Discretionary Review Abbreviated Analysis

Date: August 8, 2013
Case No.: **2013.0757D**
Project Address: **300 WINFIELD STREET**
Permit Application: 2013.0322.2868
Zoning: RH-2 [Residential House, Two-Family]
40-X Height and Bulk District
Bernal Heights Special Use District
Block/Lot: 5671 / 001
Property Owner: Lee & Nicole Horner
300 Winfield Street
San Francisco, CA 94110
DR Requestor: Arnold & Melinda Burgener
301 Prospect Avenue
San Francisco, CA 94110
Staff Contact: Erika Jackson – (415) 588-6363
erika.jackson@sfgov.org
Recommendation: **Do not take DR and approve as proposed**

The proposed scope of work is to construct a new roof deck on top of a 2 story addition at the rear of the single-family dwelling. The proposed roof deck would measure approximately 21.5 by 12 feet with a 42 inch open wood railing. The existing single family dwelling is partially located within the required rear yard and is therefore considered a legal noncomplying structure. No expansion of the building envelope is proposed under this permit.

Sight-Line Section

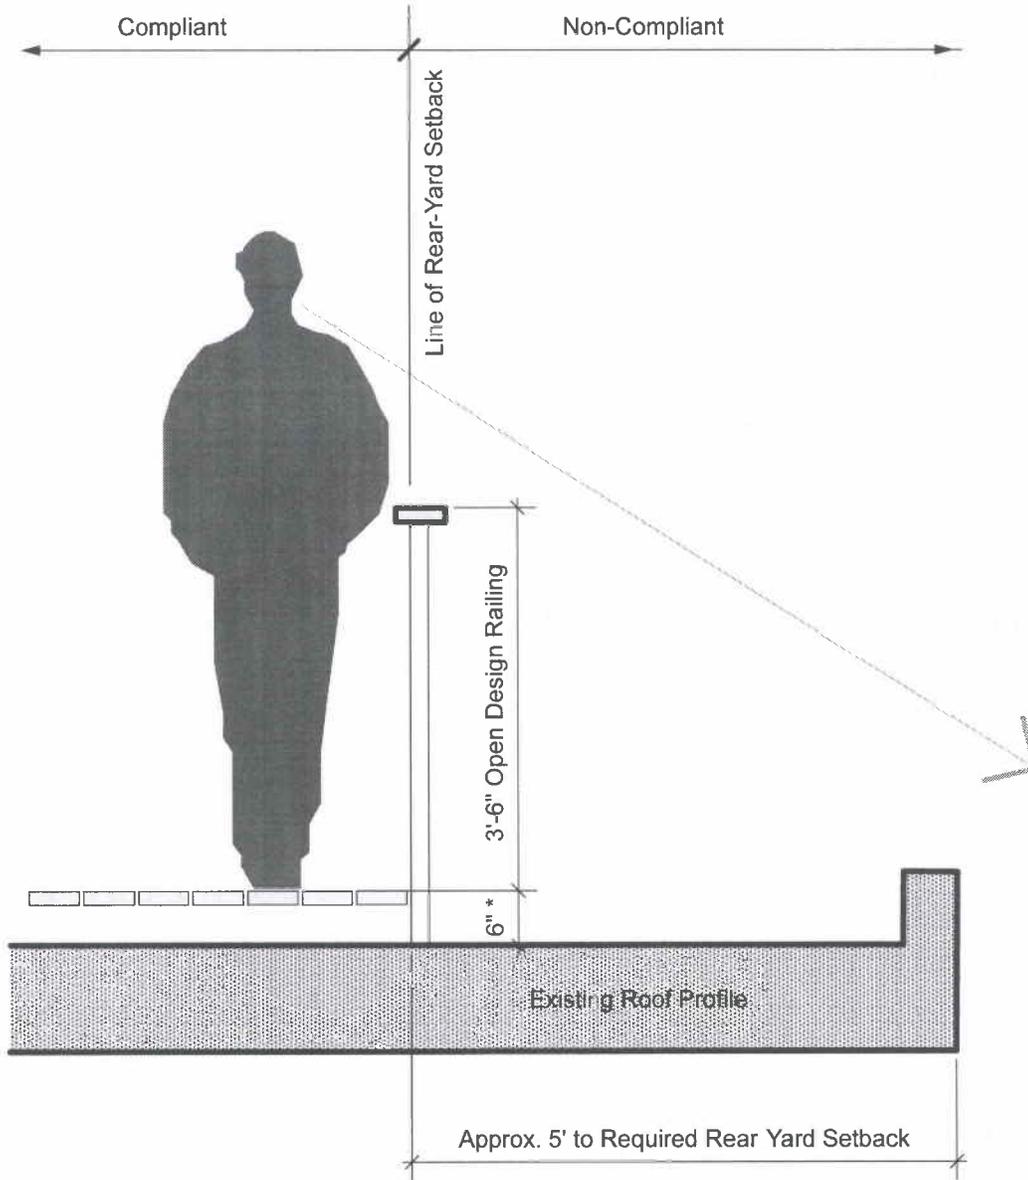
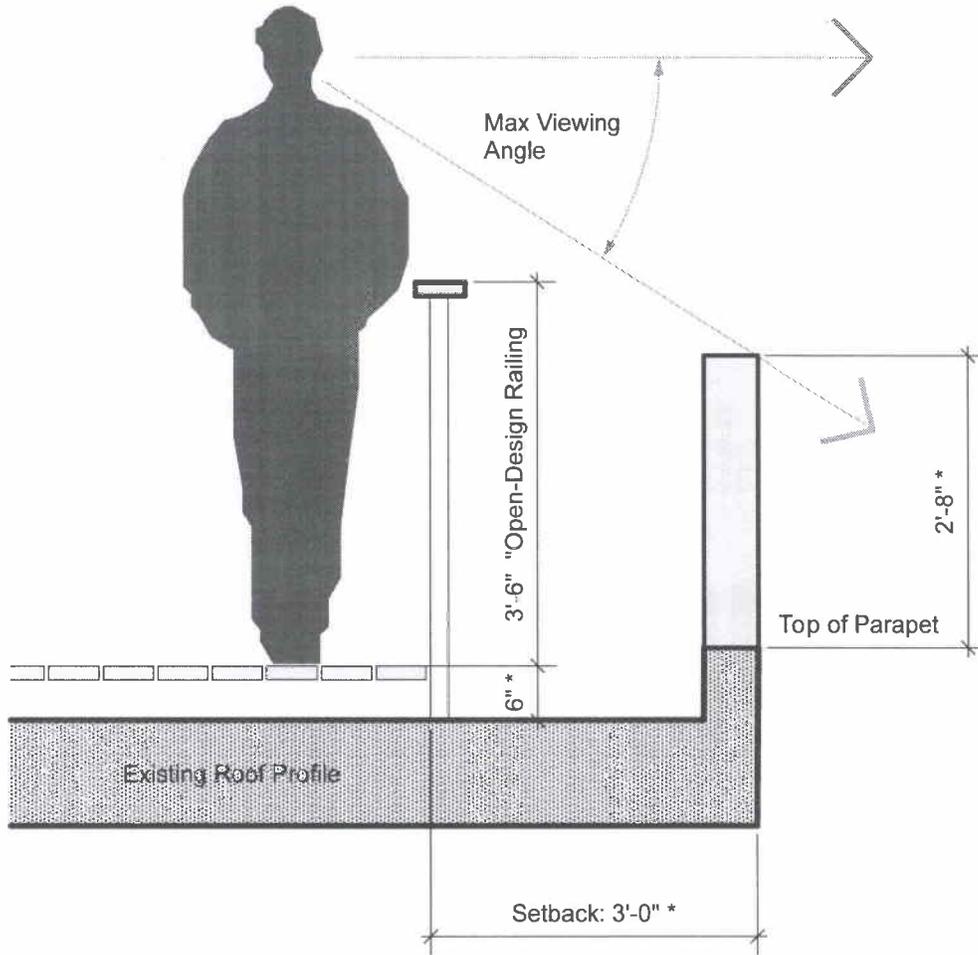
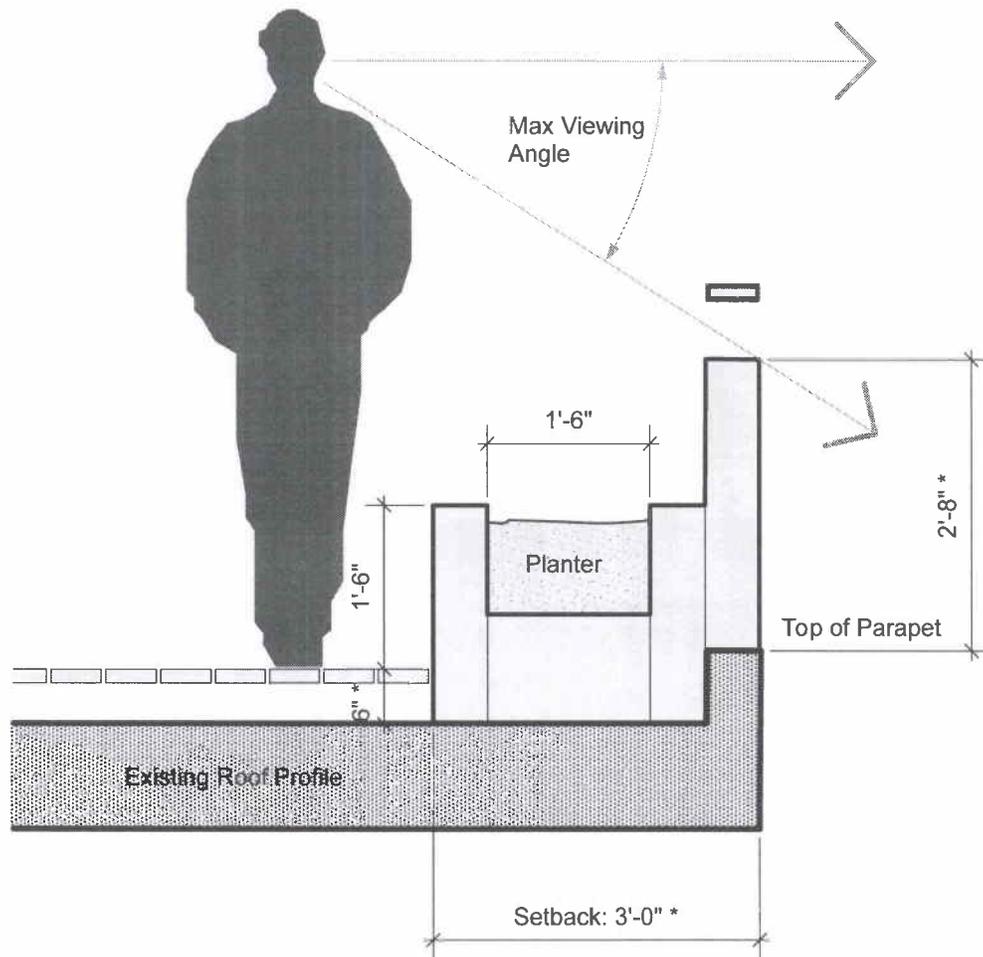
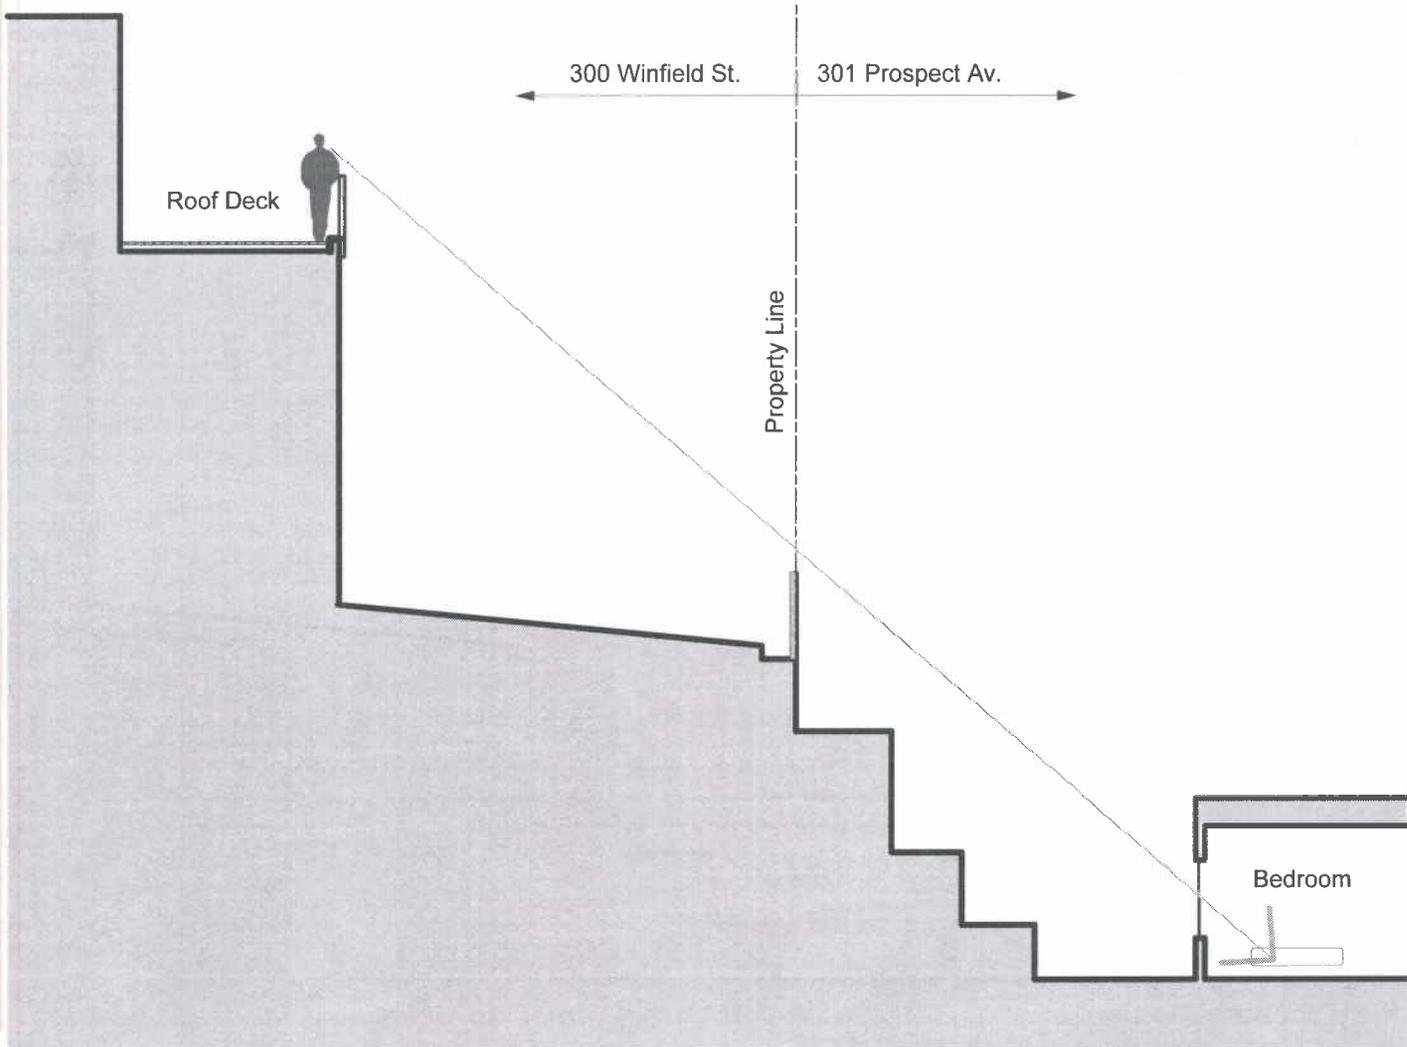
1. **5-Foot Railing Set-Back Modification:** Setting the railing back from the edge of the roof is an effective strategy because views that encroach on our privacy can be blocked by the existing 8 inch parapet (see detail A). A 5 ft setback from the parapet, verified on site, is sufficient to minimize encroaching views. Original design goals are preserved except for the area of the deck. The reduced roof deck measures approximately 21.5 by 7 feet, equal to 150 sf. This size should still be sufficient to fulfill the function of a roof deck serving a master bedroom. A five-foot setback also places the deck behind the rear-yard setback and qualifies for an over-the-counter approval.

2. **3-Foot Railing Set-Back + Parapet Modification:** Setting the railing back 3 feet from the edge of the roof increases the area of the roof deck by 30%, but is not sufficient for the existing 8 inch parapet to block views that encroach on privacy (see detail B). For this reason the parapet is raised 32 inches.

3. **Planter + Solid Railing Modification:** This modification employs a solid railing to raise the height of the parapet 32 inches in combination with a planter to create a 3 foot setback for the decking (see detail C). The combination of setback and solid railing is

sufficient to block views that encroach on our privacy. Above 32 inches the railing changes to an open design. The idea for this modification was originally proposed by the project sponsor but later withdrawn.

SUPPLEMENTAL ATTACHMENT # 2, SITE PLAN
SCALE: 3/32" = 1'-0"
7/8/2013

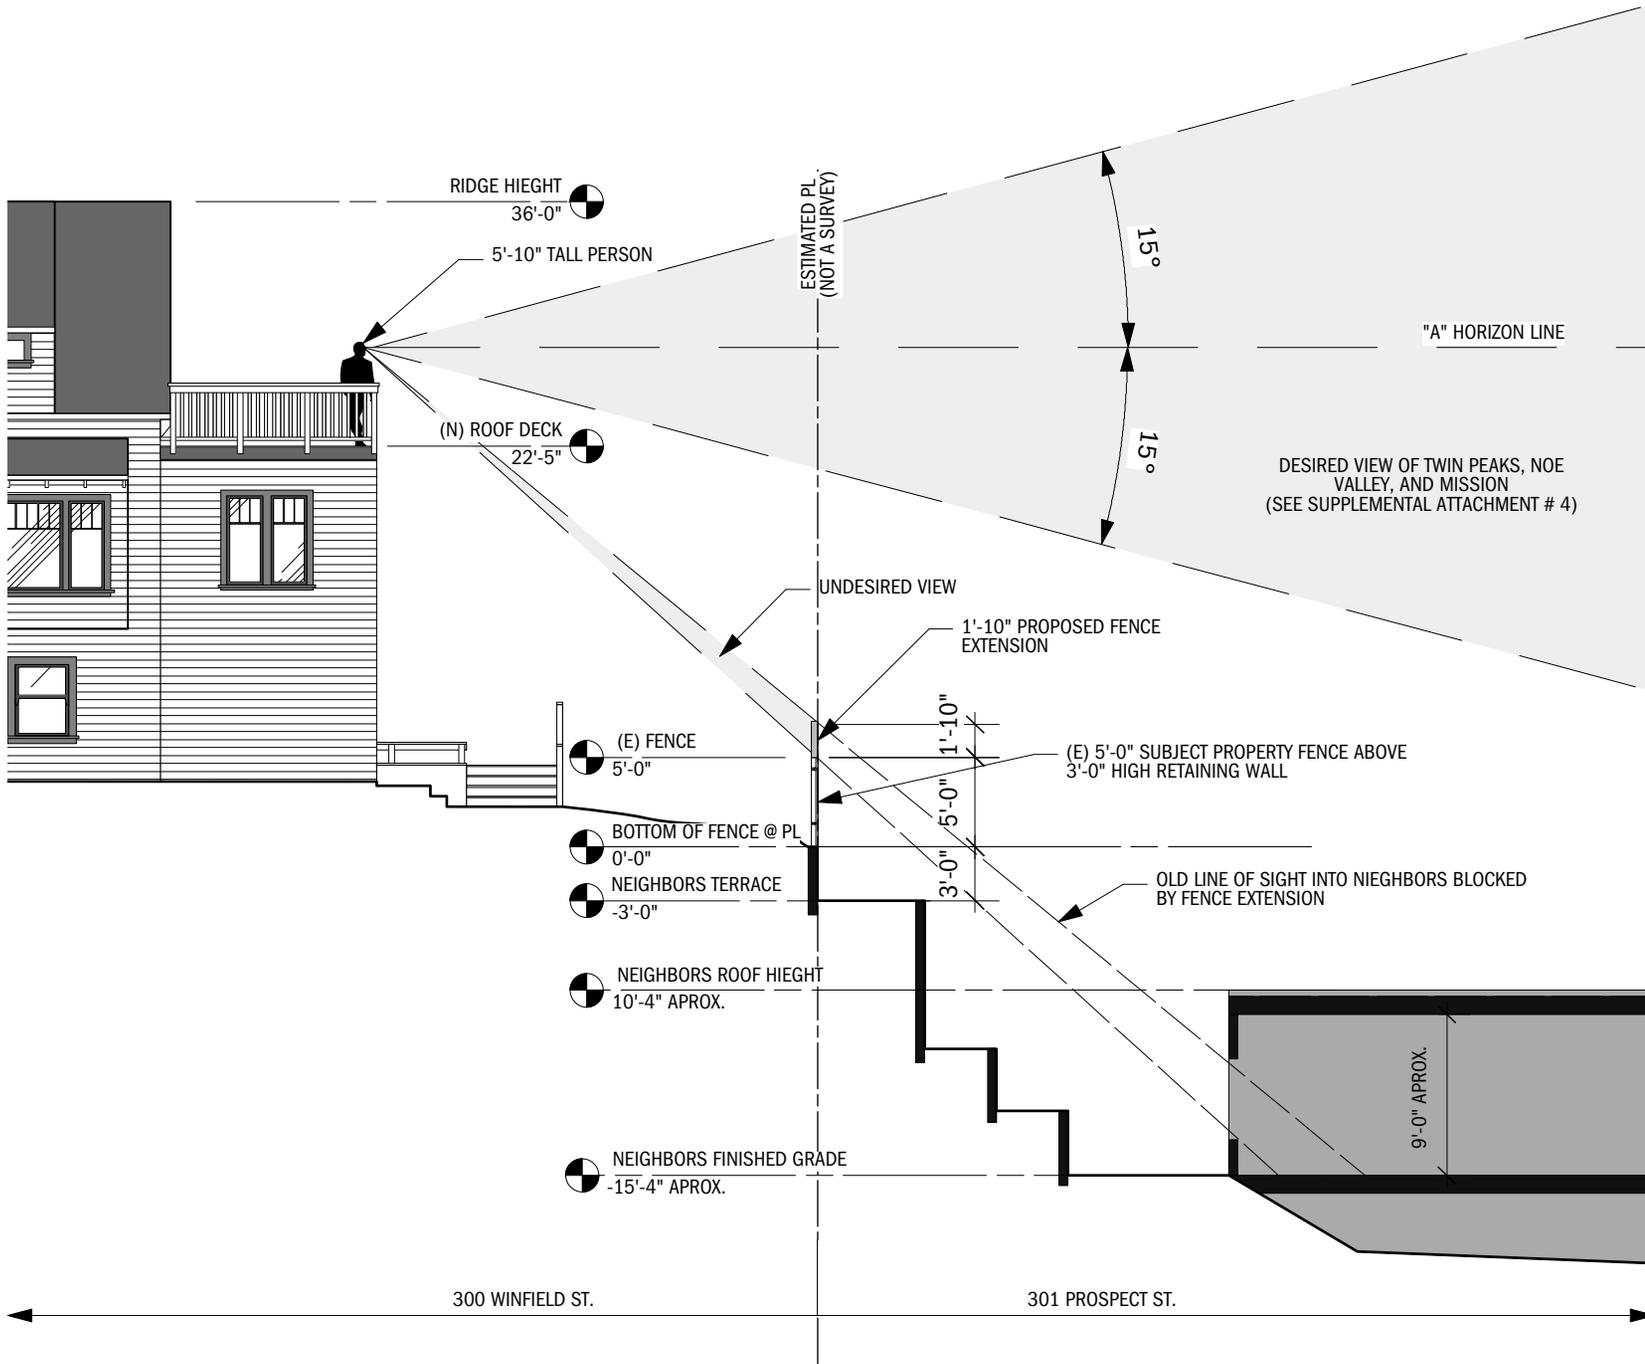
Project Sponsor: *"The DR requestor's bedroom window (sic) in question covers a small portion and is located well outside a 30 degree cone of view (attachment #2)."*

Our Response: This "30 degree cone of view" originated with a comment first made by the Horners in an email: *"We have to hold our heads at an unnatural angle, your house is not in the direct line of sight when we look out from our house holding our head in a natural pose."*

PHOTO SHOWING SCREEN TO BE 22" WIDE

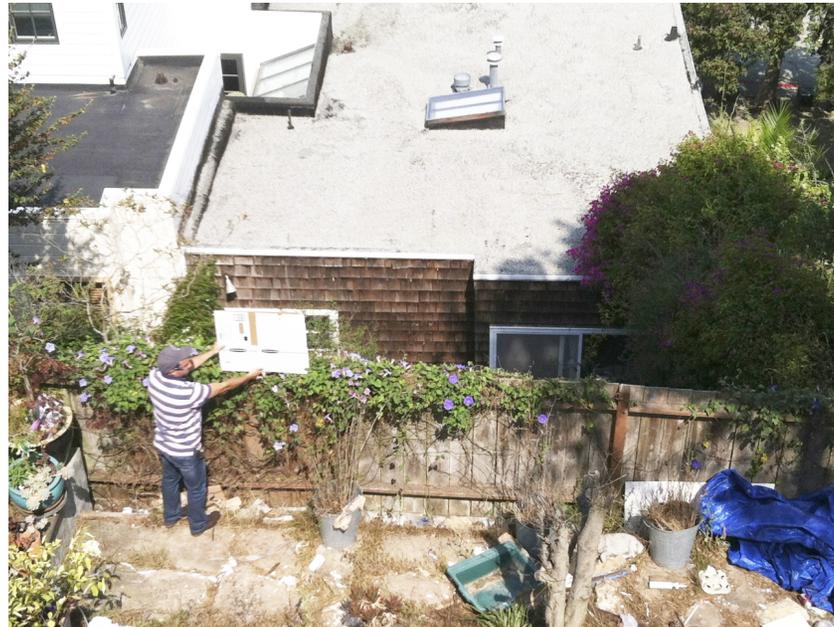
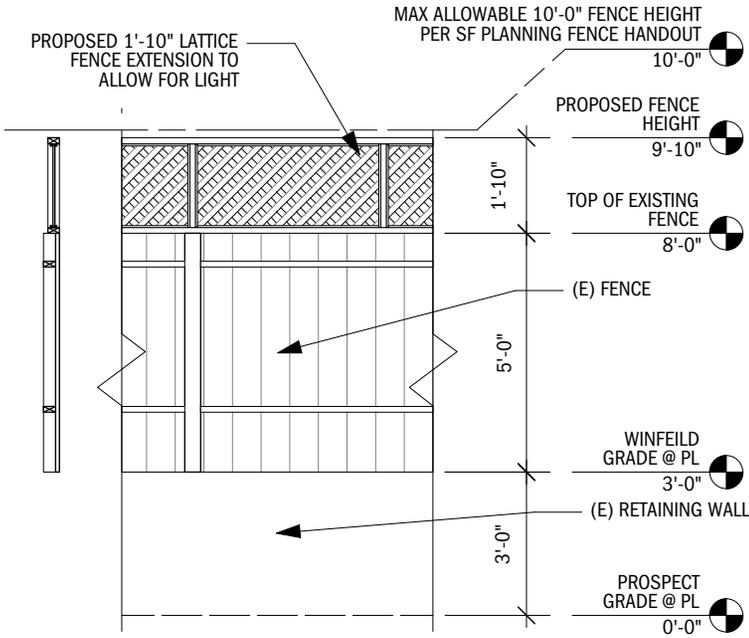
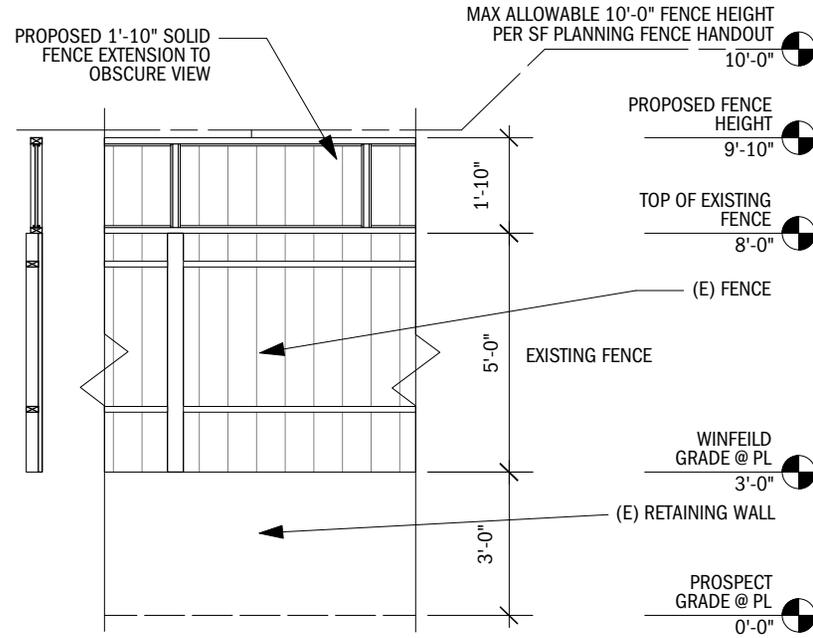
The Project Sponsor proposes a 22" fence extension to provide privacy without any setback of the roof deck railing. After correcting for errors in the Project Sponsor's procedure, this proposal is unworkable for two reasons:

1. The viewpoint of photos in Supplemental Attachment #4 and 5 is specified at the roof edge but is actually at a location several feet behind the line of the roof edge. (See Exhibit 2)
2. Photos in Supplemental Attachments #4 and 5 were also taken by an individual about 5'-5" tall, holding the camera at chest height. The Project Sponsor's Site Section states that all views originated at the eye level of a 5'-10" figure. In addition, the finished deck will add 6" to the elevation, a factor not accounted for in the photos or measurements. (See Exhibit 2)

Because the height of a fence extension is constrained by code limits, we are convinced a fence extension is not an effective way to provide privacy unless it supplements an adequate roof deck railing setback.

Our Response: Based on our own measurements, we believe a 22" fence extension would require a variance.

Our Response: This proposal is improperly characterized as "no cost to their neighbors". In fact there is a real and on-going cost: not as a one-time payment in dollars, but as an annual payment in lost sunlight. The top of the proposed extension would be more than 25' above the floor level of our house and would cast a shadow far beyond the fence. The backyard improvements of the prior owner, combined with the fence extension proposed by the Horners, would cast a shadow equivalent to a second story addition built on our rear property line.

Multiple attempts at direct negotiations were made with the neighbors. They were invited to view and walk the location of the roof deck without asking for reciprocation. All of our attempts failed to produce a successful result at multiple stages of the process. See supplemental attachment #3. We propose no changes to the deck, but are willing to compromise on a 22" extension to the height of the existing fence. As per the Planning Department's Fence Handout, a max height of 10' is allowed. We are proposing a 22" fence extension that is below that requirement. See supplemental attachment #3, #5 and #6. In considering their concerns over light and privacy we believe that a 22" height addition of a trellis or a translucent privacy screen on the fence would maximize their existing privacy, and allow sunlight to penetrate through the weave. Alternatively, we propose a 22" solid fence extension, should the DR Requestor prefer.

The client has minimal rear yard space, which is located at a slope. This has been acknowledged by the DR requestor. The roof deck would provide the client with maximum use of their property, and the proposed 22" height addition on the fence will provide privacy. The DR Requestor may choose between a 22" solid extension of the fence, or a 22" lattice extension, see Supplemental Attachment #6. We believe this is a fair compromise, and the client is willing to pay for the addition at no cost to their neighbor.
